From: Vitale, Matthew J - DNR
Sent: Friday, May 21, 2021 1:55 PM
To: Langdon, Robert
Cc: Huber, Mark
Subject: Requesting Additional Information - Site Investigation work Plan, Blackhawk Junction, BRRTS # 02-12-552357
Attachments: Proposed MWs.pdf

CLIENT PRAIRIE DU CHIEN REDEVELOPMENT AUTHORITY	PROJECT NO.	25221094.00	ENGINEER	SCS ENGINEERS 2830 DAIRY DRIVE MADISON, WI 53718-6751 PHONE: (608) 224-2830	FIGURE 3
	DRAWN BY:	04/05/2021	MRH		
	APPROVED BY:	04/16/2021	REL 05/12/2021		
	BLACKHAWK JUNCTION REDEVELOPMENT 700 EAST BLACKHAWK AVENUE PRAIRIE DU CHIEN, WISCONSIN				
SITE		GROUNDWATER RESULTS AND PROPOSED MONITORING WELLS

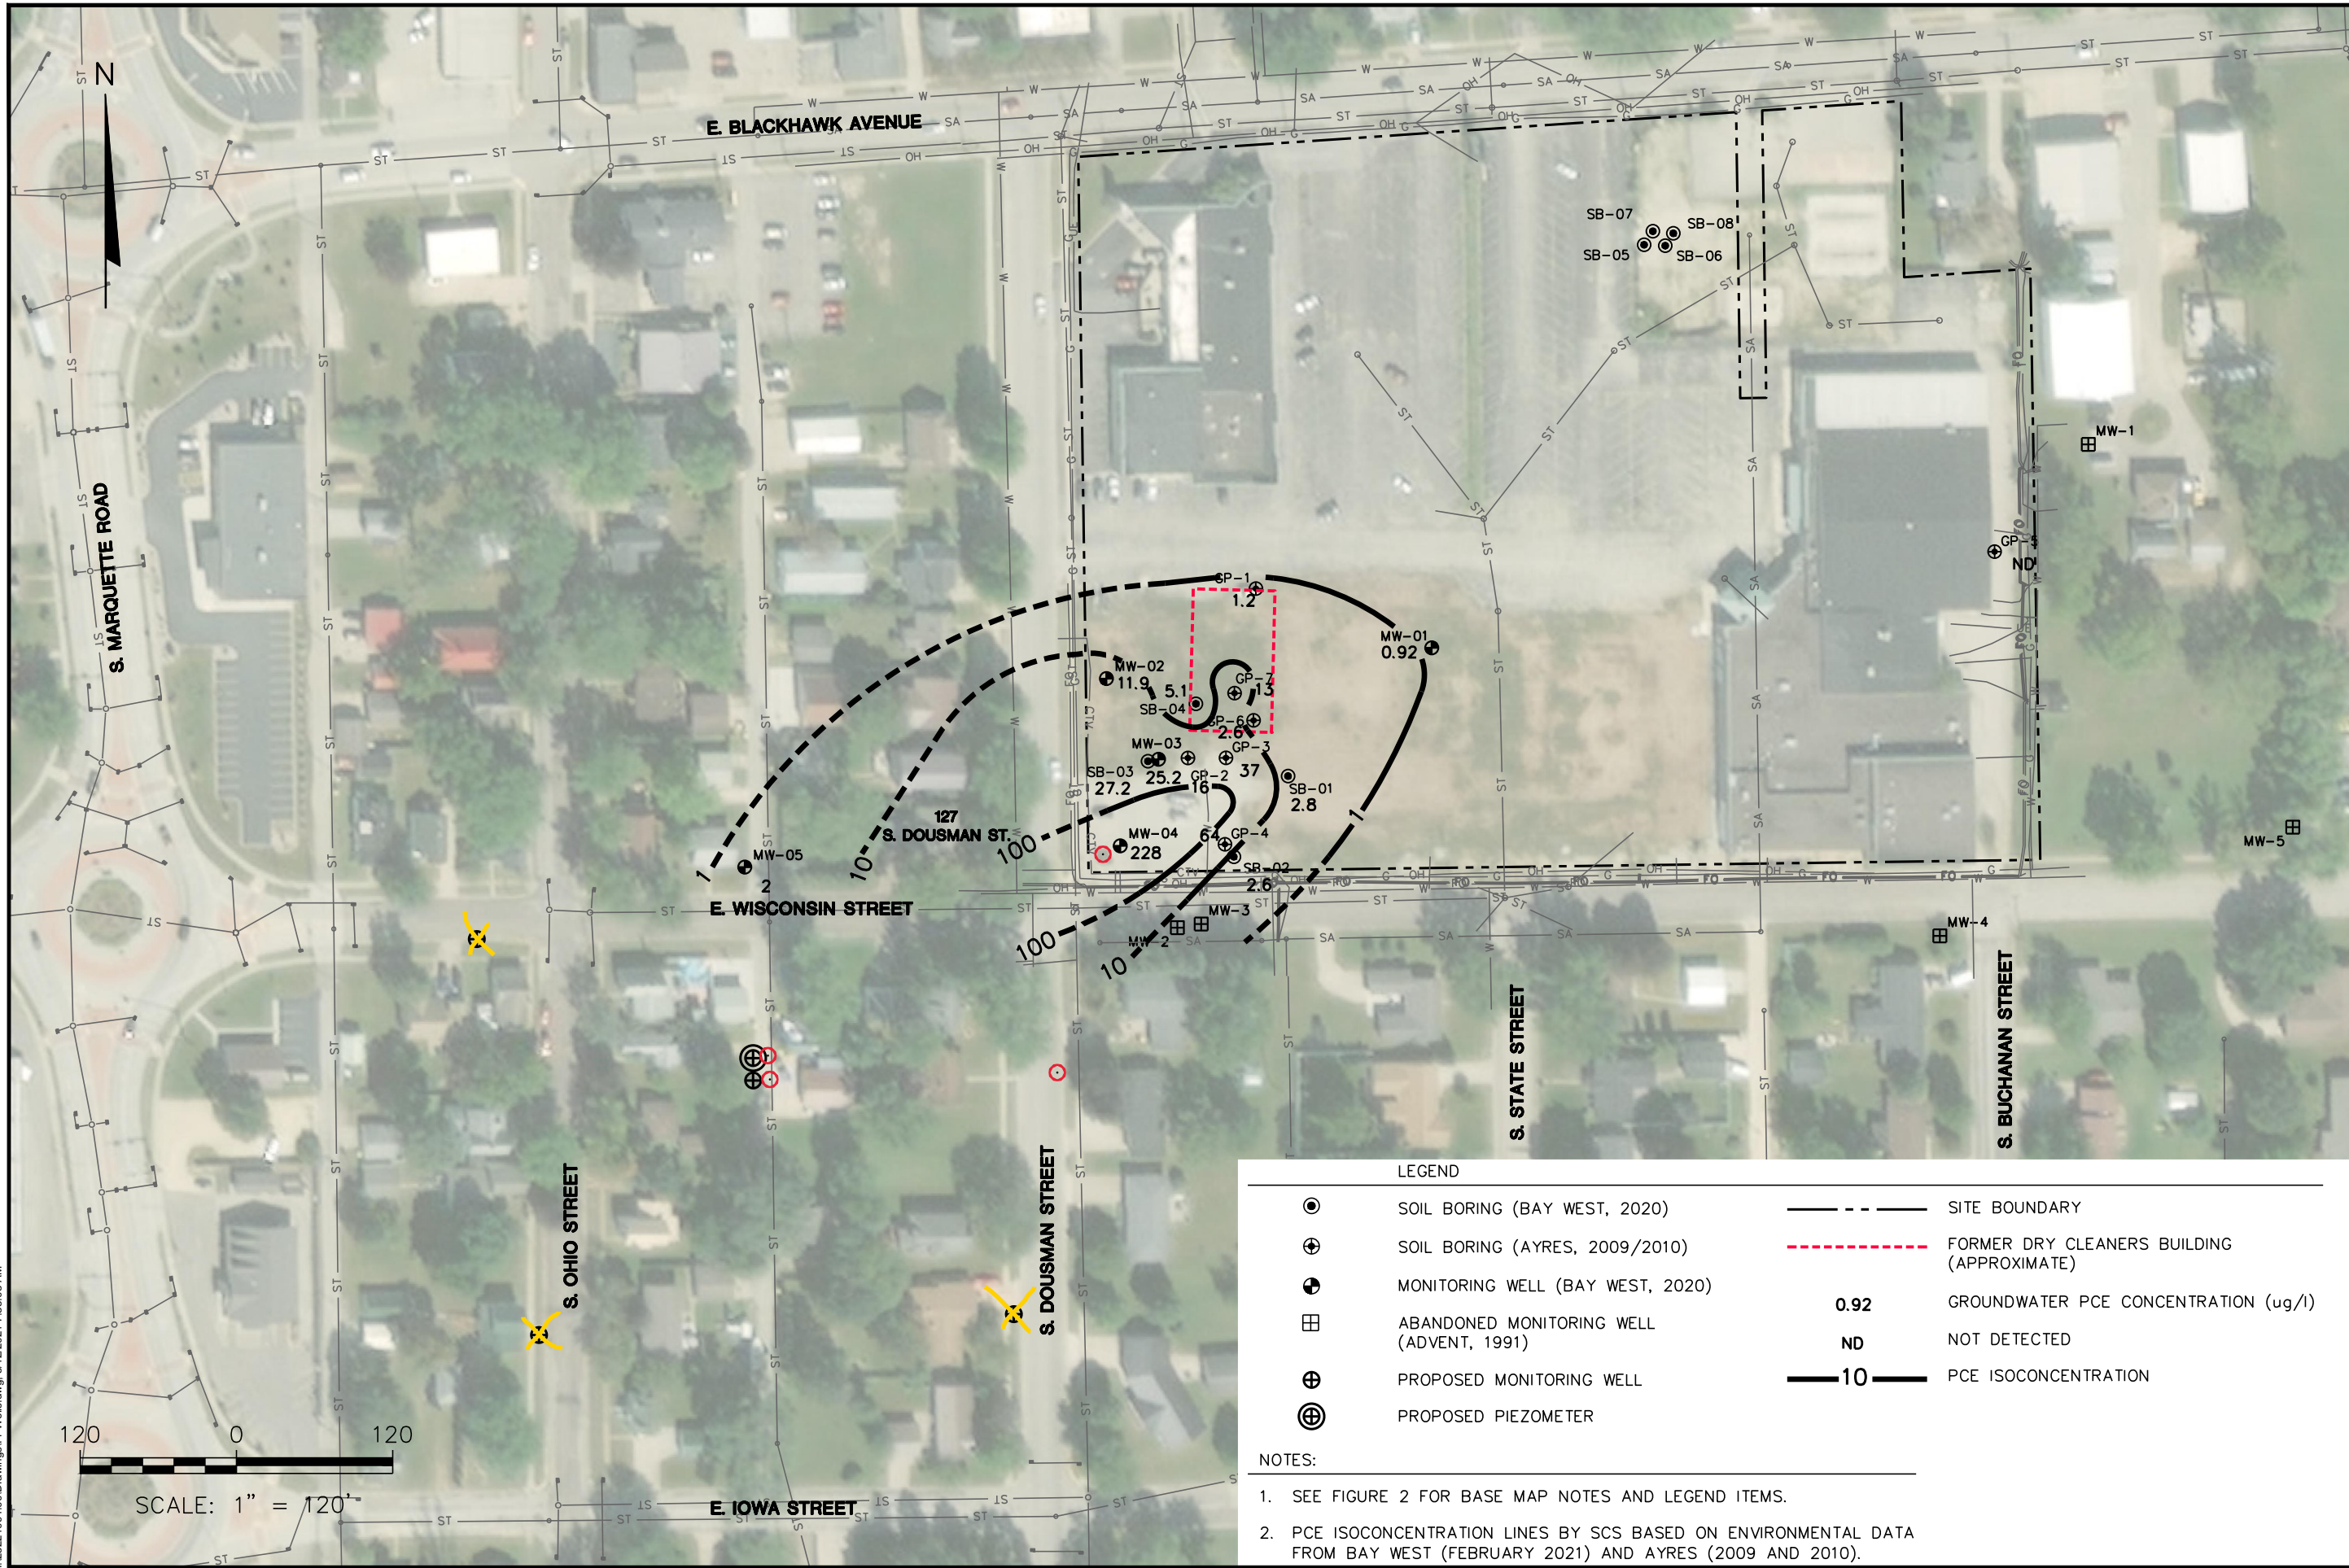
I am in the process of reviewing the SIWP submitted for the Blackhawk Junction Site. I have some concerns over the placement of the new monitoring wells and piezometer:

- A piezometer should be installed nearby MW-04 to assess the vertical extent of contamination in the source area. There is a downward vertical gradient (described in references found in the PH I ESA).
- The Proposed well on S. Dousman Street should be moved further north, approximately parallel with the proposed MW and PZ in the alley to the west. Sampling here will also help screen for additional VI concerns.
- The Proposed well furthest West on E. Wisconsin Street is likely unneeded because PCE concentrations at MW-05 has been at or below the PAL for the first two sample rounds.
- The SIWP proposed installing 3 MWs and one PZ, though the map showed a total of 5 new wells. The changes above would install 2 MWs and 2 PZs, keeping with the written proposal.

A final consideration is to discuss with the city about their willingness to install additional wells all in one mobilization, anticipating that a PZ at MW-04 or the proposed alley MW will have enforcement standard exceedances. Potential locations would be a PZ by MW-05 and the S. Ohio St well originally marked on the map. These wells would not be needed if the extent is defined by the above wells, but if needed at a later time, may delay completion of the site investigation. As you know they are interested in completing the SI quickly, to gain access to Ready For Reuse funds.

I have attached a copy of the proposed well map with the updated locations marked in red. Please let me know if you agree with the updated locations and what the city thinks about the additional wells.
